## Work Order ID 124200-2

DART AEROSPACE LTD	Work Order:	124200
Description: Blade Fitting, LH / Turning Detail for D3488-1/-2	Part Number:	D3488-1
Inspection Dwg: D3488 / DSK101 Rev: B / D		Page 1 of 2

## DART SERVICE INSTRUCTION

TO AMEND INSTALLATION INSTRUCTIONS IIN-D350-636 REV. J AND INSTRUCTIONS FOR CONTINUED AIRWORTHINESS ICA-D350-636 REV. 3

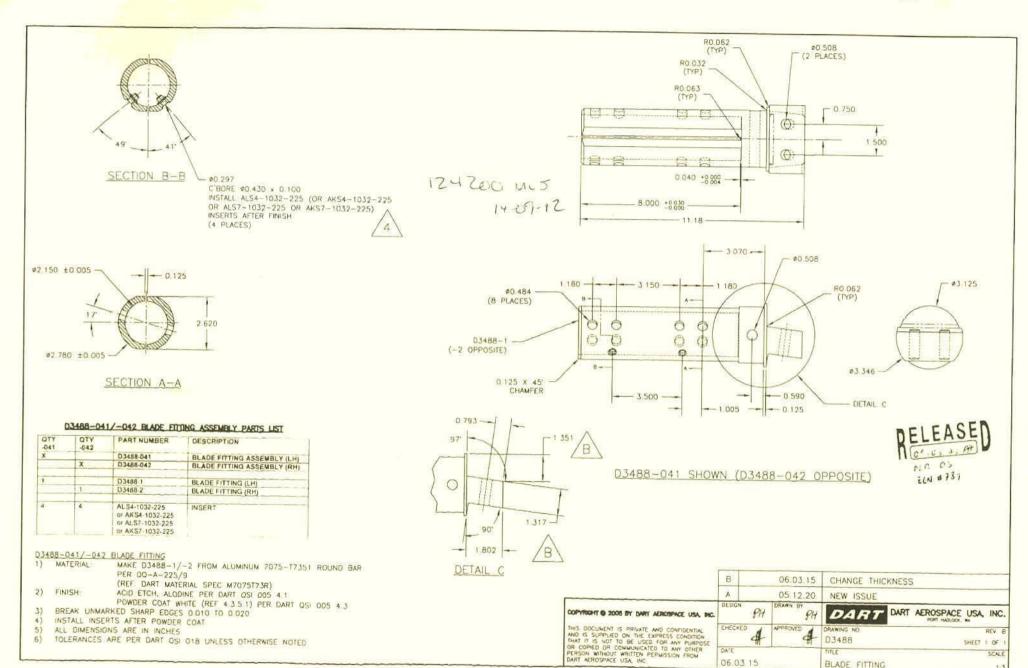
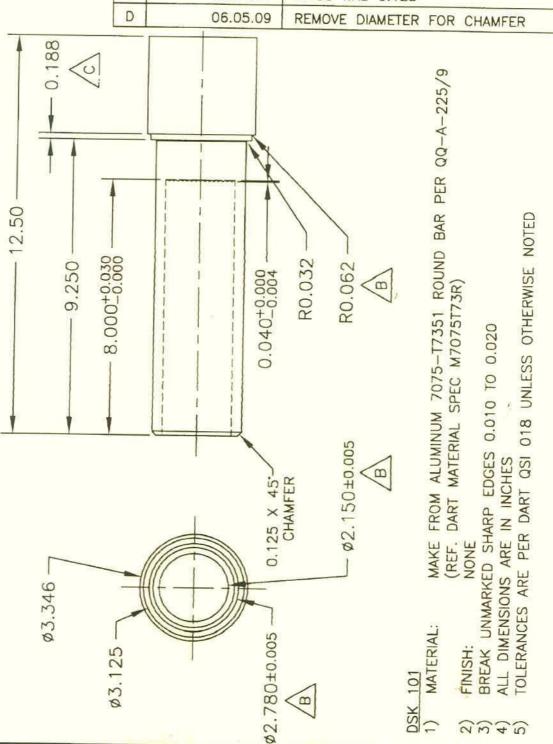
Guillaume came to see me re this rework scheme on the blade fitting and he tells me that the bushings were press fitted with a 0.0005" interference.

Your email below states not to press fit the bushing however, considering the small interference, would this be acceptable to you or not?

I am OK with a tight fit on the bushing, not a press fit. I think we should write up a DSI that allows the operator to open up the hole and install a bushing. The DSI should call up the material and dimensions for the bushing so that we don't need to create a drawing for this. We are doing the work on behalf of the operator.

I think the small interference fit is ok.

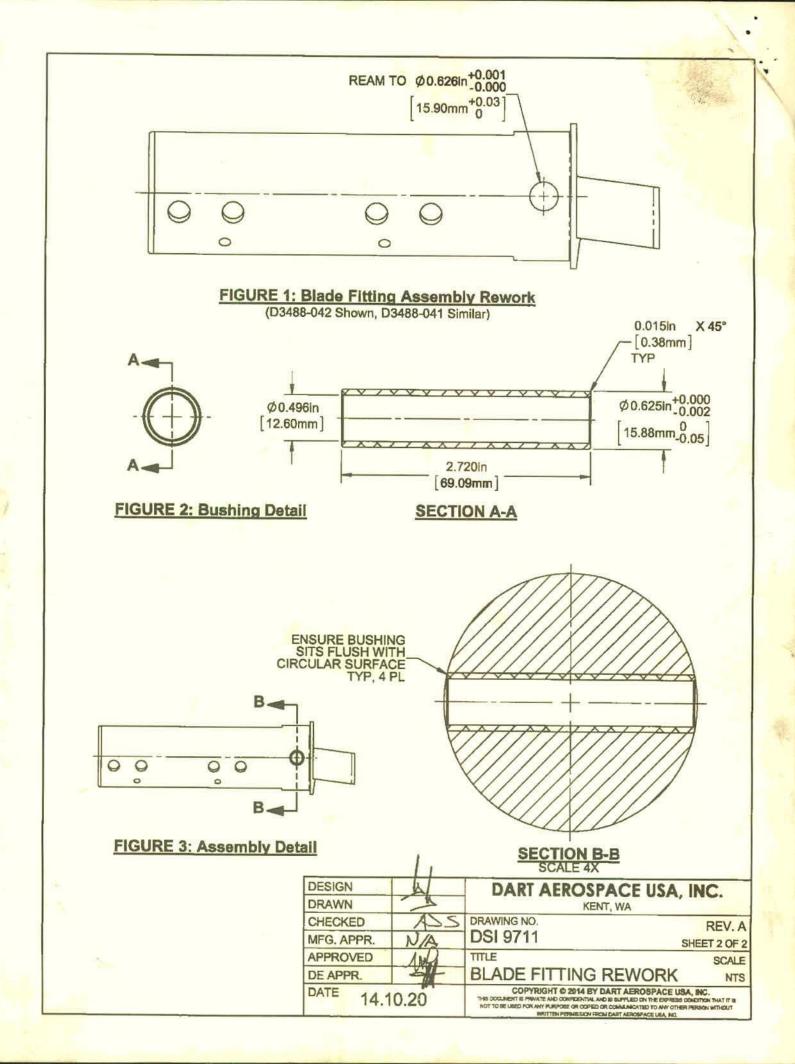
It has come to DART's attention that the fit between the 12 mm Bolt required to fasten the aft most float mounting bracket of the Aerazur Floatation System to the existing provisions in the DART Skidtubes may be too loose. In such cases, it is acceptable for the installer or maintainer to proceed with the following steps:

- 2.1 Locate Ø0.508in (12.9mm) hole in the D3488-041/-042 Blade Fittings and enlarge to Ø0.610in (15.5mm), then ream to Ø0.626in +0.001in/-0.000in (15.5mm +0.15/-0) as shown in Figure 1 of this Service Instruction.
- 2.2 Deburr and touch up finish in accordance with Chapter 5 of ICA-D350-836.

- 3.1 Fabricate qty(1) bushing for each Blade Fitting Assembly In accordance with Figure 2 of this Service Instruction and to the following material specifications: 7075-T73 (or 7075-T7351/T73510/T73511) round bar per AMS-QQ-A-200/11 or AMS-QQ-A-225/9.
- 3.2 Ensure the bushings can be installed into the holes that have been reworked on the D3488-041/-042 Blade Fitting Assemblies: the edges of the bushing should not protrude from the surface of the D3488-041/-042 Blade Fitting Assemblies. Adjust length of bushings to clear as required.

- 4.1 Bond bushings to the D3488-041/-042 Blade Fitting Assemblies using Proseal 890 Class B or AMS-S-8802 Class B sealant or 3M DP460 Scotch-Weld Epoxy Adhesive In accordance with the manufacturer's instructions. Ensure the inside of the bushings are free from sealant or adhesive. Refer to Figure 3 of this Service Instruction.
- 4.2 Allow sealant or adhesive to cure in accordance with the manufacturer's instructions.
- 4.3 Install the reworked D3488-041/-042 Blade Fitting Assemblles in accordance with Chapter 3.5 of IIN-D350-636 or Chapter 32.4 of ICA-D350-636.
